An  
Coimisiún  
Pleanála

## Inspector's Addendum Report

**ABP-320352-24**

<b>Development</b>	'The Fort Dunree Project' - Conservation led restoration and upgrade of the existing visitor experience at Fort Dunree
<b>Location</b>	Fort Dunree, Dunree, Buncrana, Co. Donegal, F93 C424
<b>Local Authority</b>	Donegal County Council
<b>Type of Application</b>	Application for approval made under Section 177(AE) of the Planning and Development Act, 2000 (local authority development requiring appropriate assessment).
<b>Prescribed Bodies</b>	Development Applications Unit Failte Ireland
<b>Observer(s)</b>	Cathal Friel Cathal Kelly Ciaran and Siobhan Tourish Cllr. Fionan Bradley David Dickson Football Special Ltd Gareth Evans International Fund for Ireland James A Sharkey

**Figure 2-2 Location of Trial Pits 17, 18 and IT03**

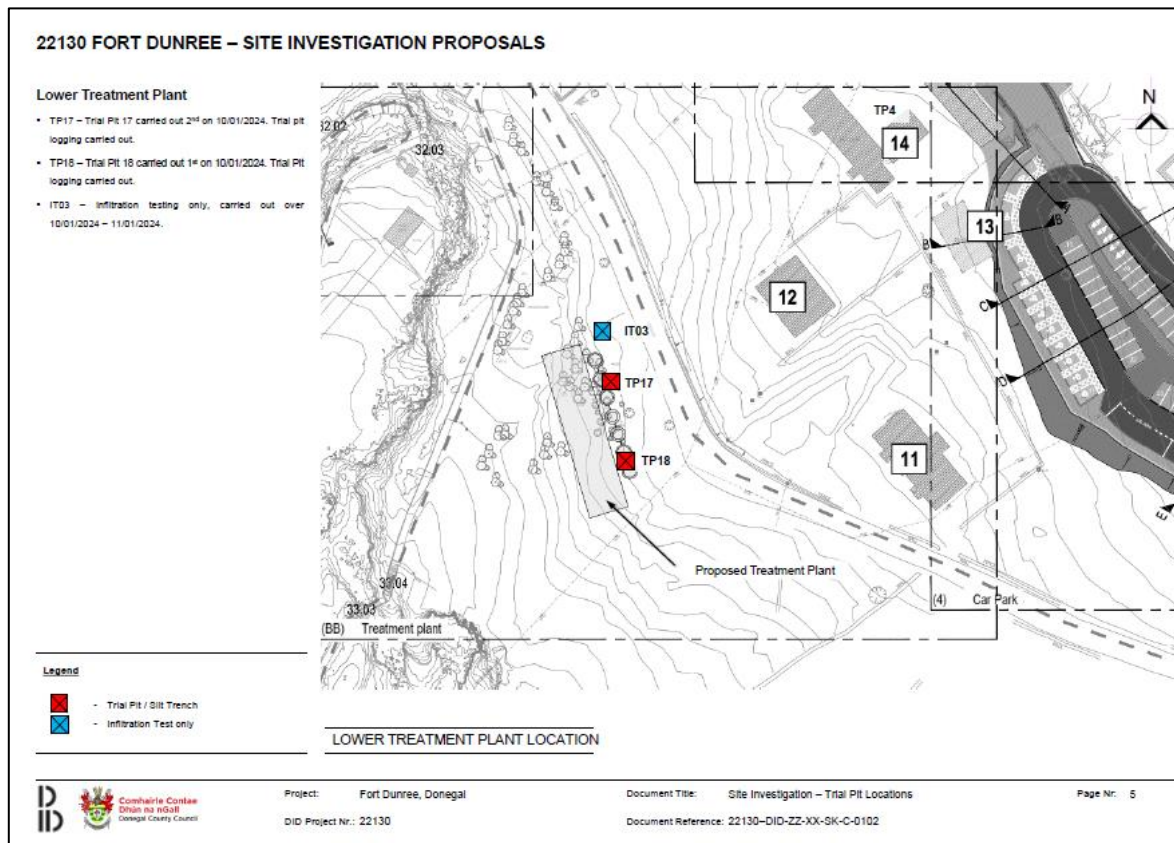
2.4.2. The applicants' responses to the RFI will now be discussed. In relation to Part A of the RFI, the applicant advised that as part of an investigative trial hole survey conducted over the entire site, two trial holes (TPs 17 and 18) were excavated adjacent to the proposed polishing filter. The trial hole logs were assessed and soil depths of 0.250m and 0.750m respectively were reported for these sites. Further investigation of the location of these trial pits show that they were excavated along a road in an area which has a steep slope (see photographs associated with trial pits 17 and 18). I have concerns that the depths recorded at this location may reflect the contouring carried out to accommodate the nearby road and not be an accurate

reflection of the expected depth of soil in this area. I also noted that the map (Figure 2-2 below) included in the RFI report identified the location of the surface percolation test holes referred to in the SCR at 2.3.7. This map also shows the location of the proposed treatment plant but not the polishing filter which suggests that IT03 may not be located in a representative location to assess the effectiveness of the proposed polishing filter.

- 3.1.4. The surface percolation tests for the museum site were recorded at a location (IT03) which is approximately 40m from the proposed location of the polishing filter. No photographs of these percolation test holes were provided. The PV results were 1.75, 2 and 55 which when averaged, gave a value of 19.83. None of the three individual PV results obtained were within the preferred 3-20 range which coupled with the distance from the proposed polishing filter is of concern. There is a risk that PV values under the sand polishing filter will be too low (<3) which could indicate a direct discharge into the bedrock or fractured bedrock. The trial hole survey for the entire site has demonstrated significant variability in soil depth and bedrock level therefore, the outcome of the PV tests conducted 40m away and their relevance to the proposed polishing filter location is questionable.

**Figure 2-3 Location of Trial Pits 01(IT01), 02(IT02) and TP03**

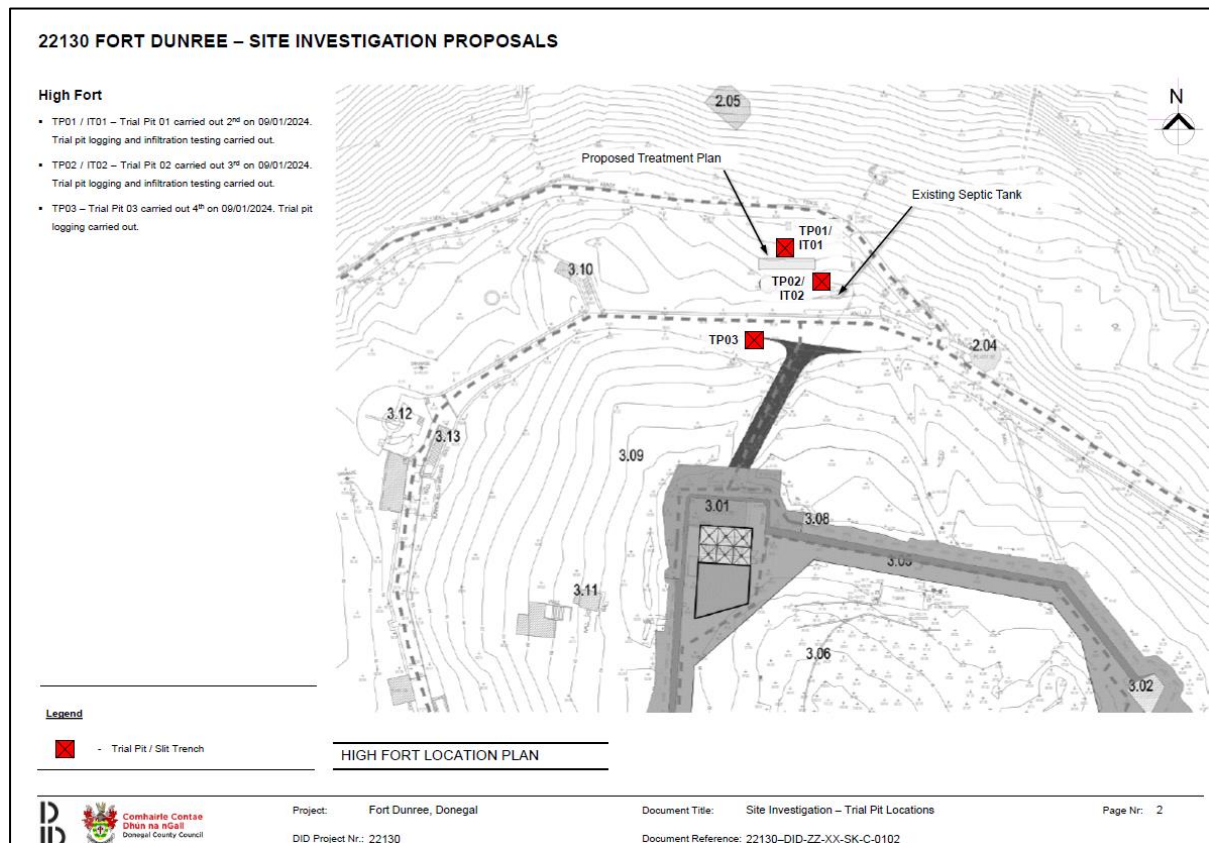
Although not specifically requested in the RFI, the report submitted by the applicant also included a map which appeared to identify the location of infiltration testing holes near the Hill Fort site. This area (see Figure 2-3 below) is located directly north of the Hill Fort itself. No information was provided by the applicant on the results of any infiltration testing conducted at this location. Three trial holes were excavated in this area. Trial Pit 1 (+IT01) was reported to have 0.5m of soil present, TP02 (+IT02) was reported to have 0.5m of soil present and TP03 which is further south adjacent to a road was found to have no soil present and was made up entirely of surface aggregate and weathered rock and boulders. TP03 is not expected to be

representative of the likely ground conditions for the polishing filter proposed for this site.

**Figure 2-4 Proposed location of the settlement tanks, treatment system and polishing filter**

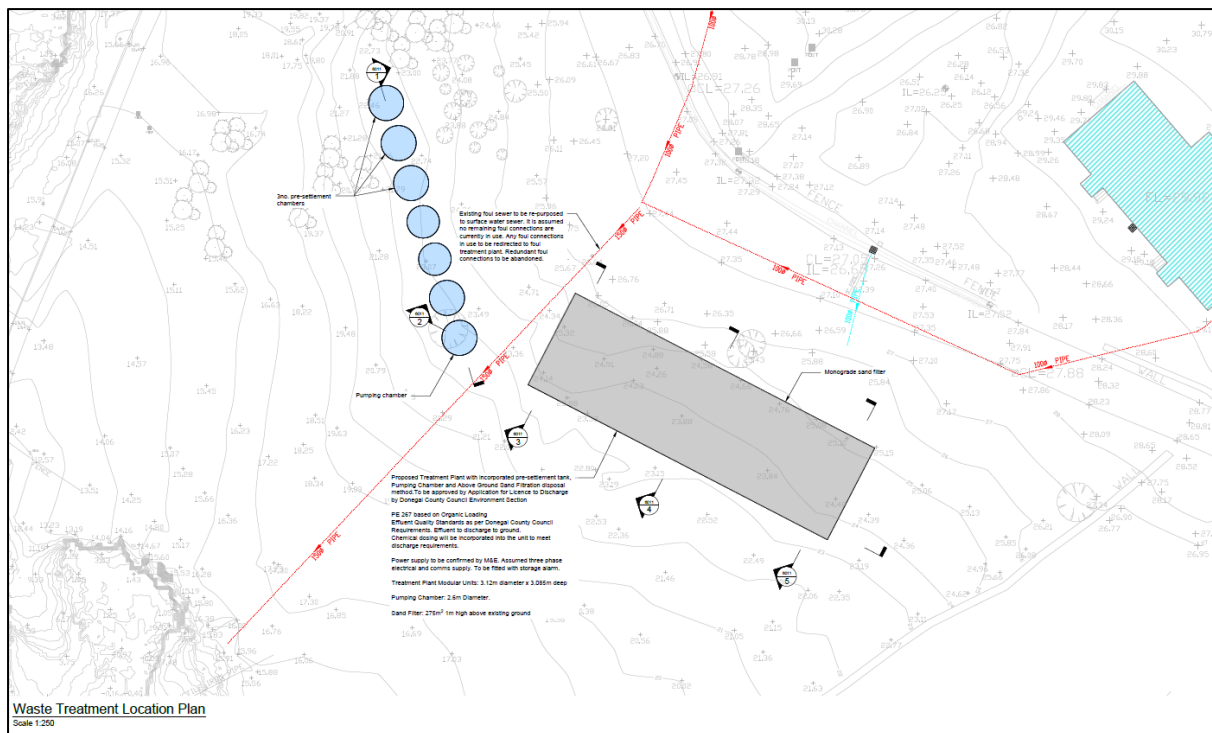
2.4.3. Part B of the RFI related to a proposed settlement tank associated with the wastewater treatment system to serve the museum. Appendix C of the submitted FI details the proposed wastewater treatment system for this part of the site. It is proposed that three concrete settlement chamber tanks are installed in series prior to the biological units. Each of these settlement tanks has a diameter of 3.12m, a depth of 3.09m and an effective volume of 18m<sup>3</sup> taking account of the invert levels of the inlet and outlet pipes. According to the submitted drawings, the tanks are to be buried below ground level which will require excavating >3m into the soil/bedrock. The location of these settlement tanks was provided on a map (see Figure 2.4 below).

- 3.1.1. The Code of Practice, 2021 specifies separation distances between elements of a proposed wastewater treatment system and various sensitive receptors and features. These are listed in table 6.2 (page 28 of the CoP) and include a 50m separation distance from a lake or foreshore. The applicants included a location plan for the polishing filter to serve the museum area which is shown in figure 2.4 above. I have mapped (approximately) the 50m separation distance from the foreshore at this location and overlain the proposed location of the polishing filter. This can be seen in figure 3-1 above. This illustrates that some of the proposed polishing filter may be less than 50m from the foreshore and therefore not compliant with the requirements of the CoP. 2021.
